INVITATION TO BID
BOOSTER STATION GENERATOR PROJECT
ADDENDUM NO. 2
March 12, 2026

- Specifications – Division 26 – Electrical – Section 26 36 14 – Generator Docking Station, Part 2-Products, Paragraph 2.02 F, Exhibit A

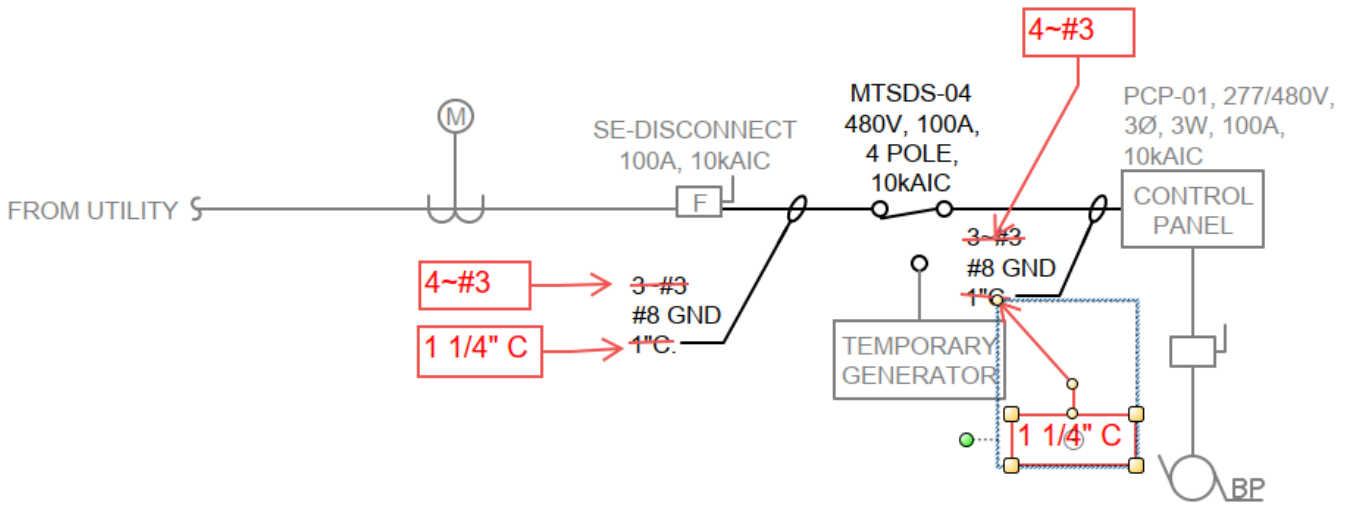
REMOVE – “and short circuit withstand rating of 65 kAIC” from the sentence. 10kAIC is appropriate since the existing equipment is all 10KAIC:

- F. Generator docking station ratings shall be as shown on the Drawings, with a factory-installed phase monitoring relay ~~and short-circuit withstand rating of 65 kAIC.~~
